DRAGONFLY MK.3 WG.666

RADIO ACCEPTANCE TRIALS

1st Part of Report No. AAE/879/1.

Radio Acceptance Trials have been carried out on Dragonfly Mk. 3 WG.666 prior to C.S.(A) release. The aircraft was fitted with TR.1520, Z.B.X., AN/APX-1 and S.C.R.718A.

FIG 5 A N A I E R E N

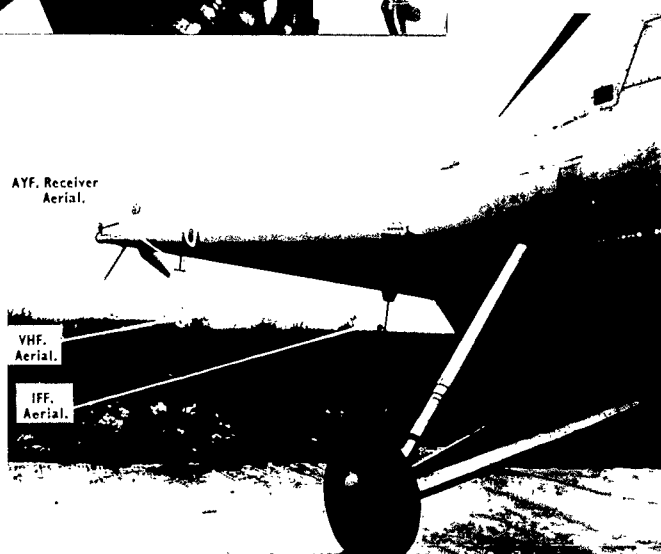
5.1.3. The aerial was mounted on the underside of the cabin (Fig. 5)

7.1.3. The receiving aerial was mounted on the aft end of the boom (Fig. 3) and the transmitting aerial under the pilot's cabin (Fig. 5), both positions were satisfactory for operational requirements.

FIG. 9

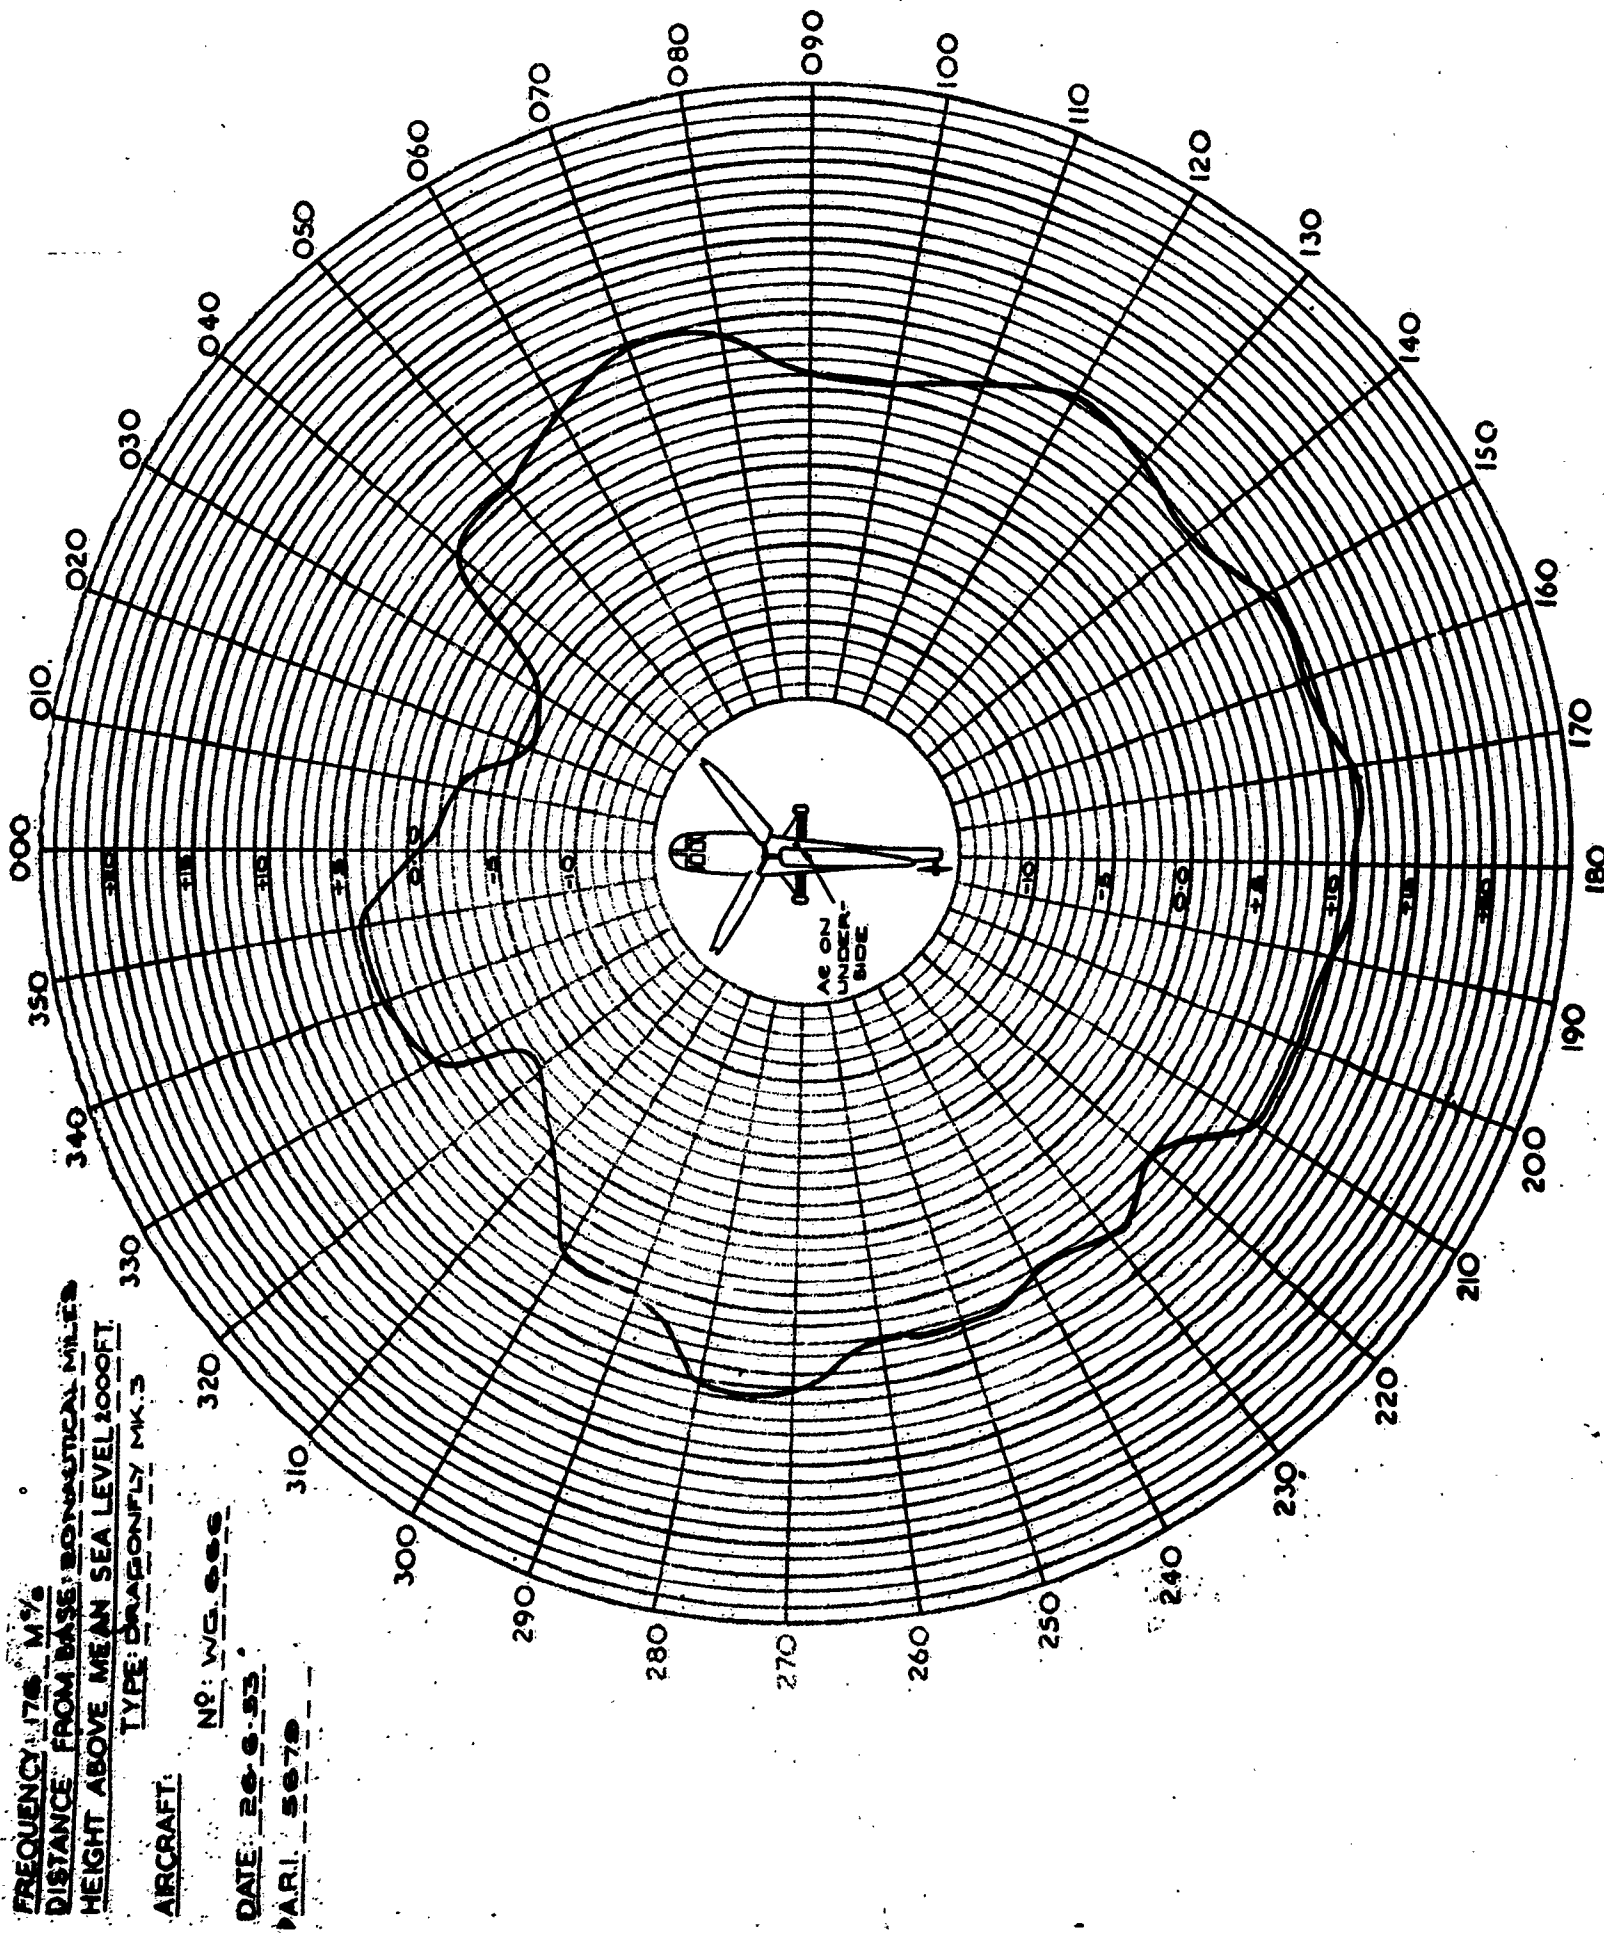
6.1.3. The I.F.F. Aerial was mounted on the forward part of the boom very close to the main fuselage (Fig. 3), resulting in severe screening of the aerial on the head aspect.

6.3.1. Polar Diagram. The results are shown in Fig. 9, and are not satisfactory due to screening by the fuselage on the forward aspects.

- (a) The coding switch cannot be reached by the operator under flight conditions.
- (b) The Aerial position is unsatisfactory due to screening by the fuselage on forward aspects, and needs re-positioning.
